Product Change Notification

111845 - 01

Change Notification #: 111845 - 01
Change Title: Intel® Server System R2224IP4LHPC and R2312P4LHPC
PCN 111845-01, Product Design
Update BIOS/ME/BMC/FRUSDR Firmware and Stand-Off
Reason for Revision: Inclusion of Additional Customers
Date of Publication: November 06, 2012

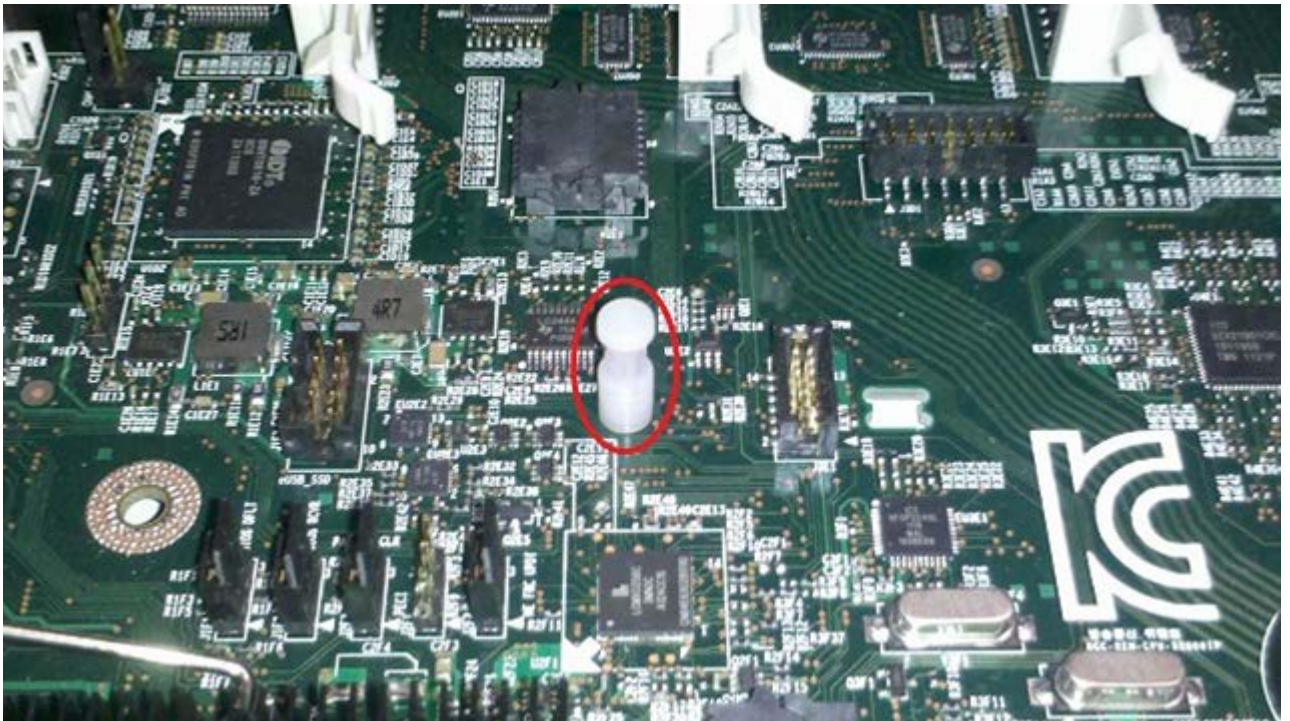
- Remove the plastic stand-off depicted below from the system accessory kit, and install the plastic stand-off on the server board:
